The Corporation of the District of Saanich

To: Mayor and Council
From: Sharon Hvozdzanski, Director of Planning
Date: November 27, 2020
Subject: Rezoning and Subdivision Application
File: REZ00622; SUB00831 • 3494 Cedar Hill Road

Figure 2: Proposed Subdivision (from plans by Envision Designs & Development)

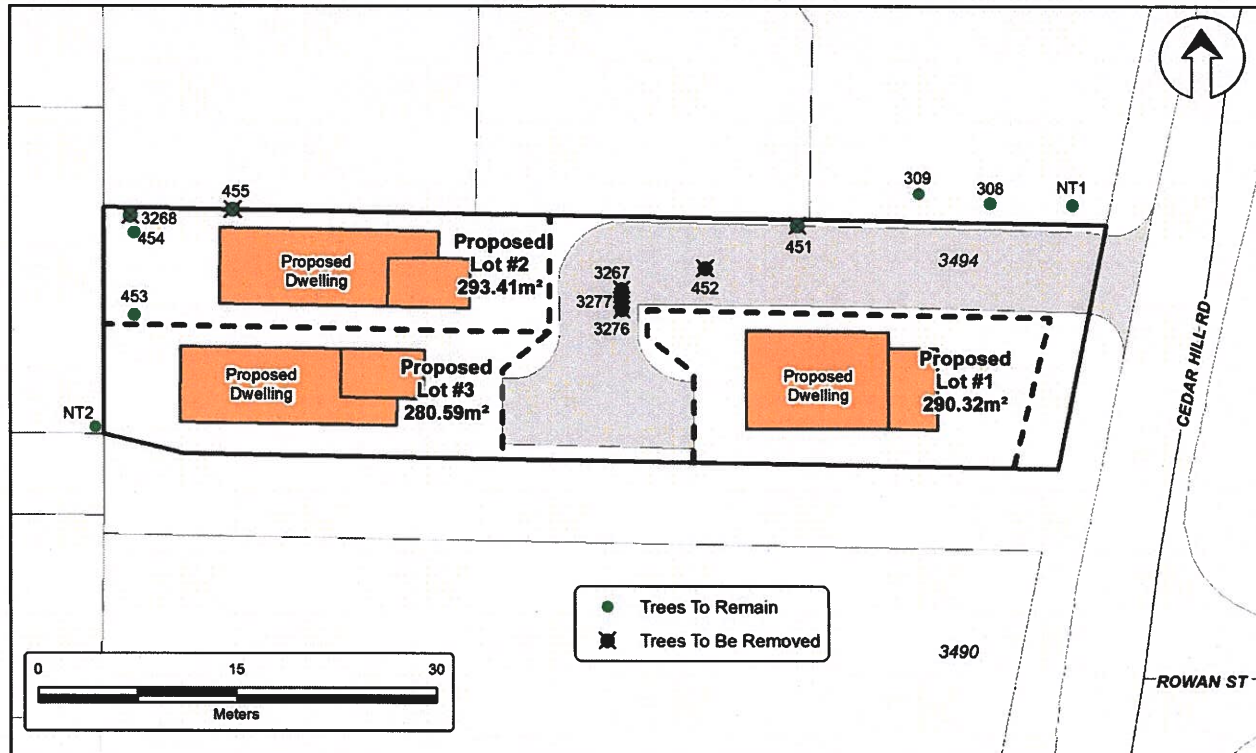
The development proposal is to rezone the 1338 m² site from the RS-6 (Single Family Dwelling) Zone to a new site-specific zone in order to accommodate a bareland strata subdivision resulting in two new lots (three lots total) for single family dwelling use (see Figure 2). The lots would range in area from 280.6 m² to 293.4 m² and would be relatively narrow with lot widths ranging from 8.8 m to 11.17 m, well below the minimum 16 m lot widths that are standard in the area.

In this case, the proposed 280.6 m² to 293.4 m² lots would be substantially smaller than the prevalent lot sizes in the neighbourhood. Such small lots would result in an excessive amount of hard surfaces for the strata road, driveways and parking areas, leaving little useable outdoor space for each parcel, and the amount of stormwater runoff would greatly increase. In addition, the possibility of secondary suites in each dwelling would require one additional on-site parking spot, which would further reduce green space and increase runoff.

A total of seven trees would require removal: six due to construction related impacts and Garry Oak #3268 is standing dead and should also be removed. Five of these are located within the proposed driveway footprint and include Douglas-fir #451, Silver Maple #452, Western Red Cedars #3267 and #3277, and Sitka Spruce #3276. The other is Douglas-fir #455 which straddles the common boundary with 1409 Nev Place. If the building on proposed Lot 2 is to be constructed at the edge of the building envelope, excavation will occur up to the base of this tree. It is likely that critical roots would be severed during excavation, making retention of this tree unlikely.

Garry Oaks #308 and #309 are located on the adjacent property at 1401 Nev Place, approximately 1.0 m and 1.5 m from the common property boundary. They are part of a grove of Garry Oak trees that are protected by a covenant. These trees are growing at a lower grade and separated by a 45-60 cm retaining wall. Despite the grade difference and depending on the depth of the retaining wall, roots from these trees may extend onto the subject property. The Report recommends arborist supervision for any excavation within their critical root zones and if large, critical roots are encountered, it will be necessary to "float" the driveway over the roots.

Saanich Parks has reviewed the Arborist's Report and has noted that the strata road as proposed would have a negative impact on covenant protected trees #308 and #309 located on the neighbouring property. Should Council approve the proposed rezoning, Parks recommends placing a covenant on this proposed development to protect the Garry Oak trees growing on 1401 Nev Place, and relocating the proposed strata road to the south side of the site. The applicant has stated that a southerly access is not the best option when considering traffic circulation/impact at Rowan Street and design/aesthetics relative to the adjacent walkway. If the application is approved, the Approving Officer could consider a tree protection covenant through the subdivision approval process.

Parks has also noted that branches from Garry Oak tree #454 extend over the proposed building envelope for Lot 2. Depending on the house location, two branches estimated at approximately 15 cm in diameter may require removal. Parks would review any request to alter this tree at the Building Permit stage and a Tree Permit would be required. Permission from the adjacent property owner would also be required.

Based on the anticipated tree loss, 10 replacement trees would be required on the site. No replacement trees are shown on the proposed site plan. If the application is successful, this requirement could be addressed at the Building Permit stage.

Figure 3: Proposed House Design (Lot 1) (from plans by *Envision Designs & Development*)

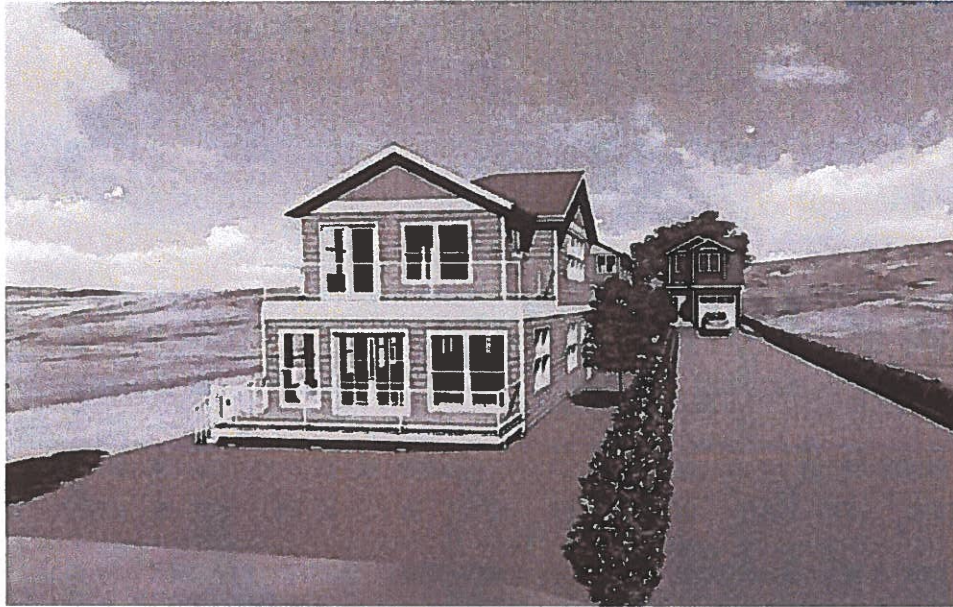
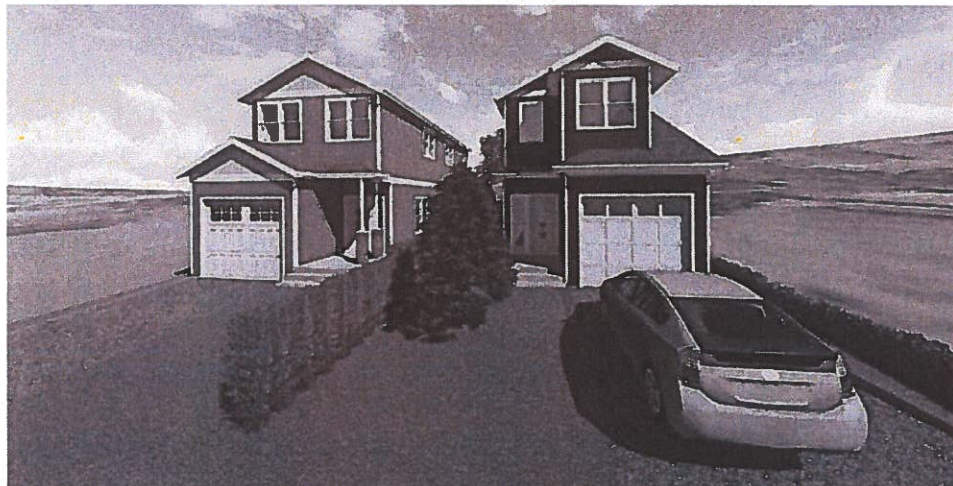
As is standard for similar infill applications, staff have requested house designs or a registered Building Scheme to assist Council in ensuring that the infill housing is sympathetic to its neighbours and natural surroundings. The applicant has stated that his client does not wish to commit to house designs or a building scheme. Images have been provided to indicate what the proposed dwellings may look like, however, the applicant is unwilling to secure these concepts via covenant (see Figures 3 and 4).

While the Shelbourne Valley Action Plan suggests this property remain as a single family use, the proposed lot size would be substantially smaller than the prevalent lot sizes in the neighbourhood. Contrary to Quadra Local Area Plan policy 4.3, the applicant is not willing to commit to specific house designs or a building scheme for the new dwellings to be constructed on the proposed lots.
